Access Assessment Report

Illoura Place - 28 Elizabeth Street, Liverpool

Reference No: 113165-Access-r3

Date: 2 November 2021

2.10. Design Items Requiring Attention

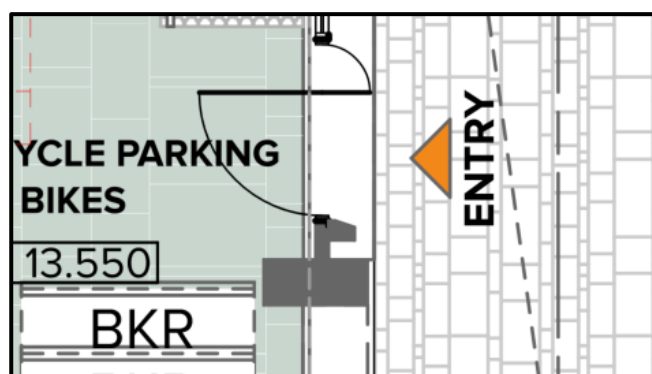
2.10.1. Mezzanine Access – Clause D3.1

The end of trip facilities proposed on the mezzanine have not been provided with the provision of a lift and would therefore not be accessible. It would be required to make access available via a lift, otherwise seek a Performance Solution to allow for no access being required to this storey.

2.10.2. Entry doorway to End of Trip – Clause D3.1

Concern is raised with regards to gaining access to the Ground Floor EOT. Current the doorways does not maintained the required latchside clearance of 530mm as required by AS1428.1-2009.

It would be required that the plans are updated to ensure that compliance circulation is made available.
